ADDENDUM No.02

CAP24-037-RFP02

Quinte Health BGH – Phase 2 – Generator & Fuel System Replacement Project

July 24, 2026

2.3 Drawing M9-02 – Mechanical Demolition Sheet-2 (New issue)

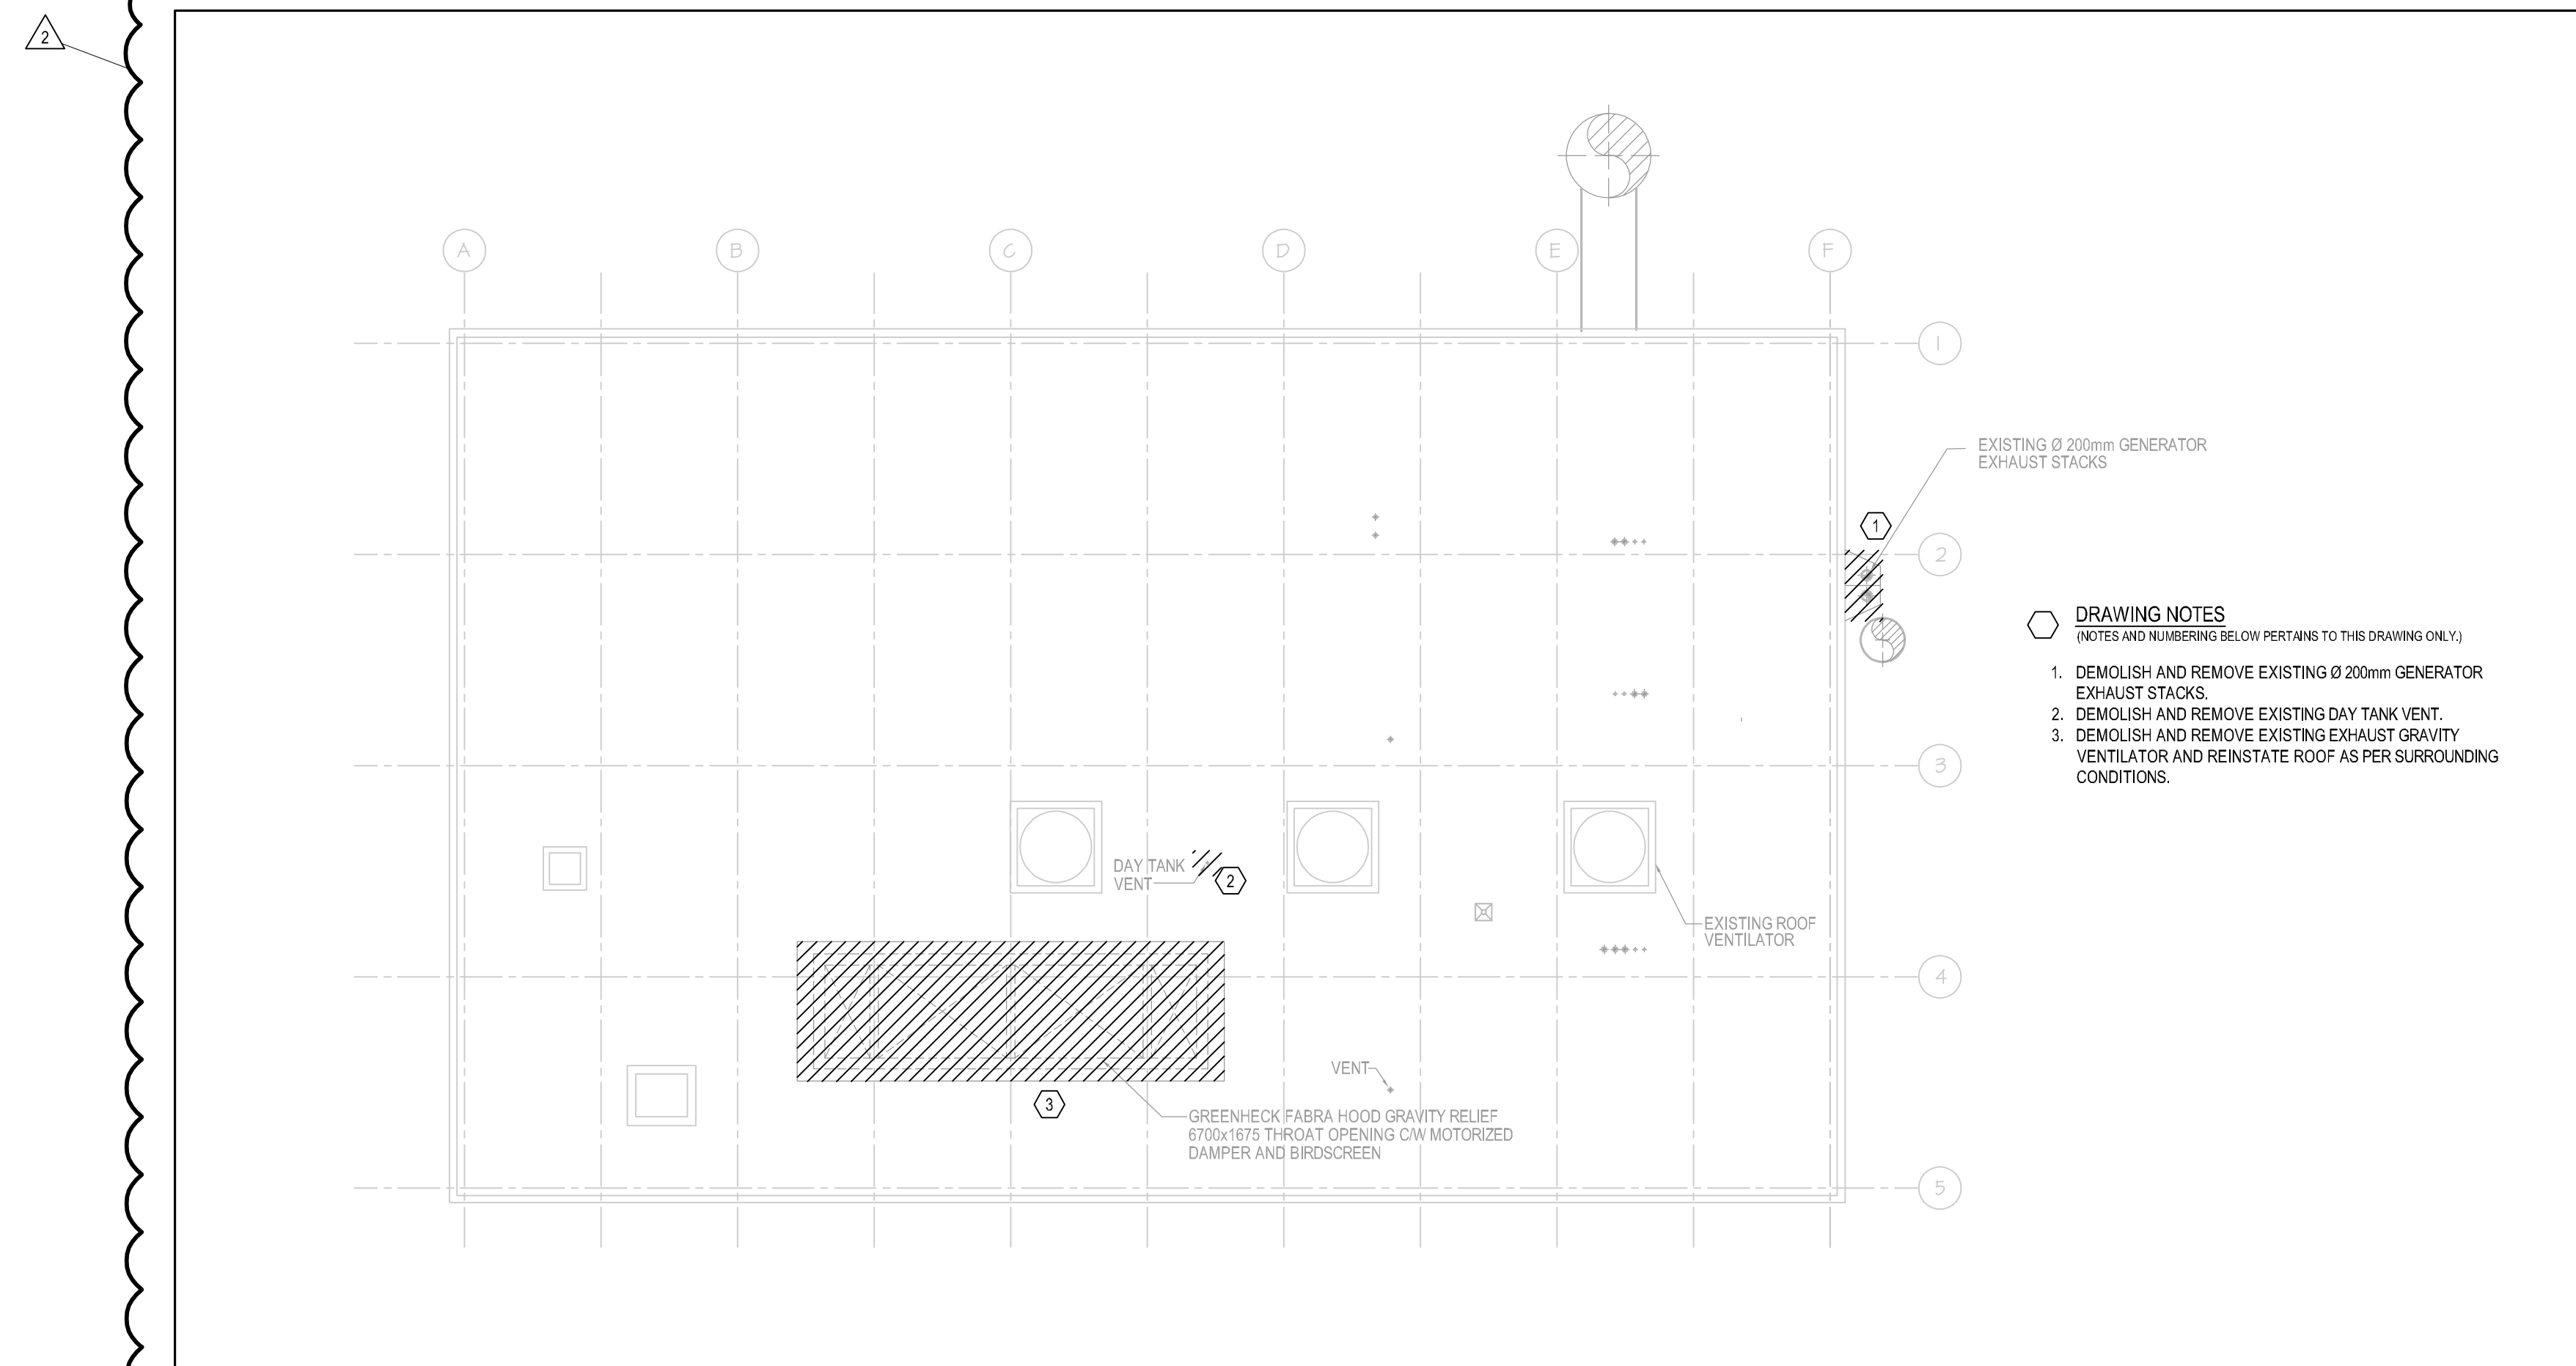
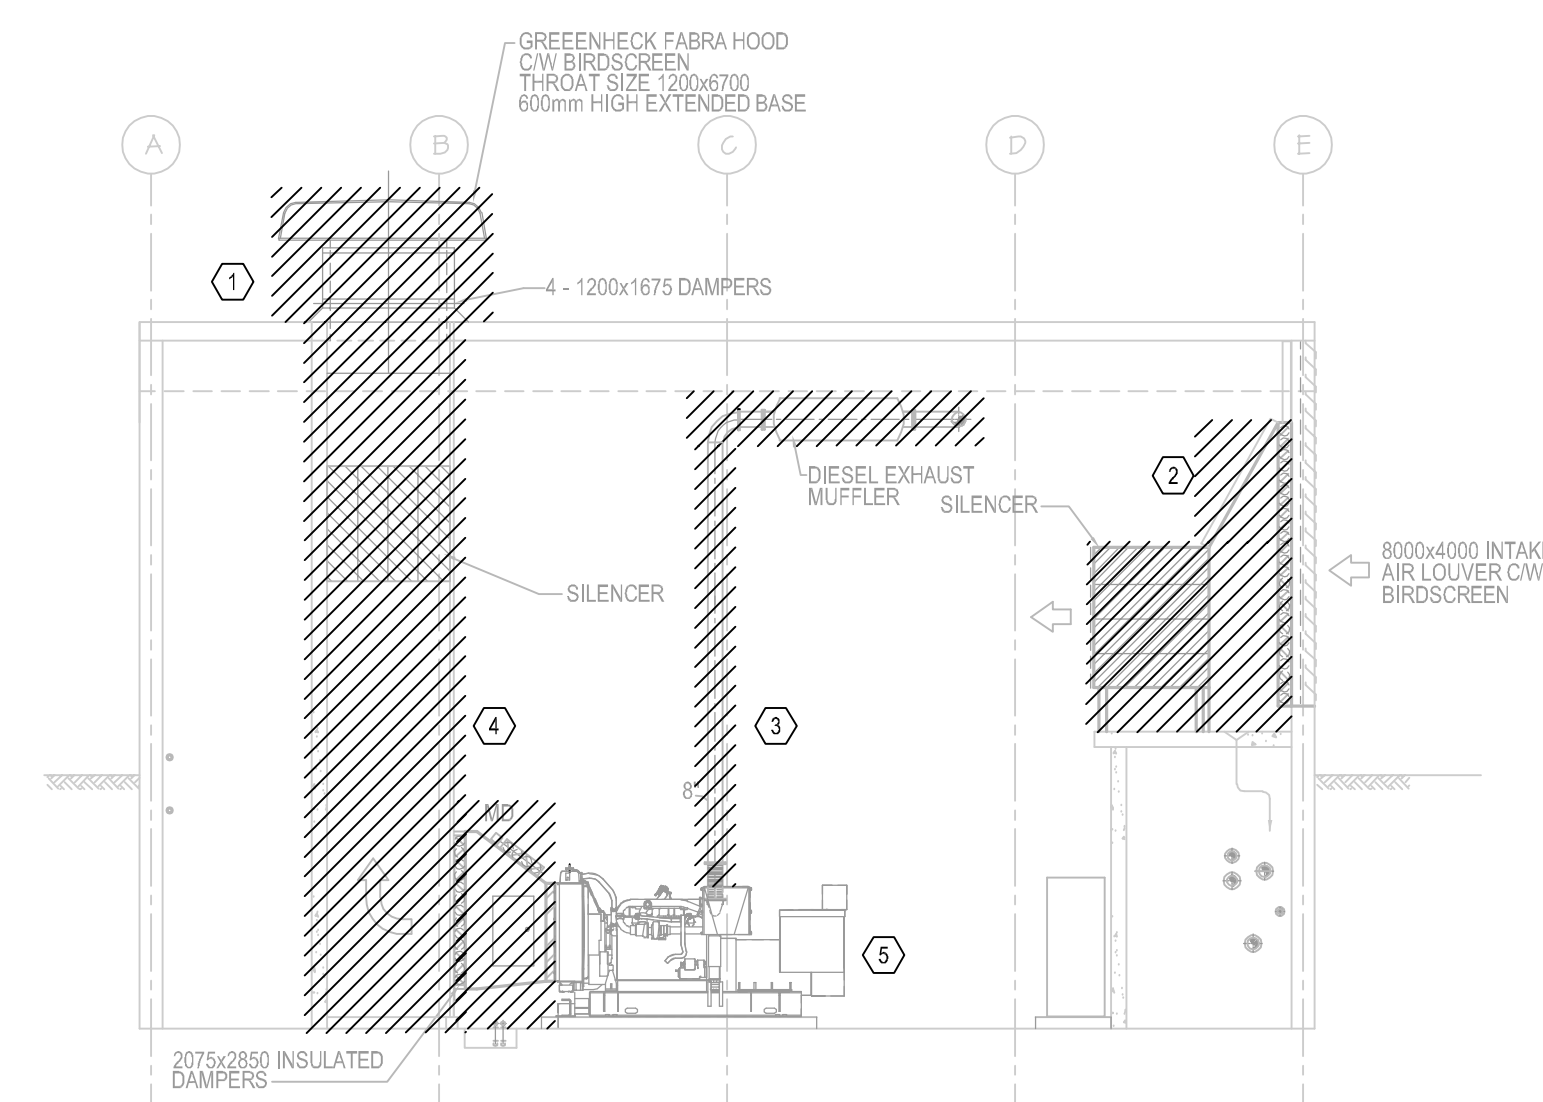
- .1 Demolition scope clarified.
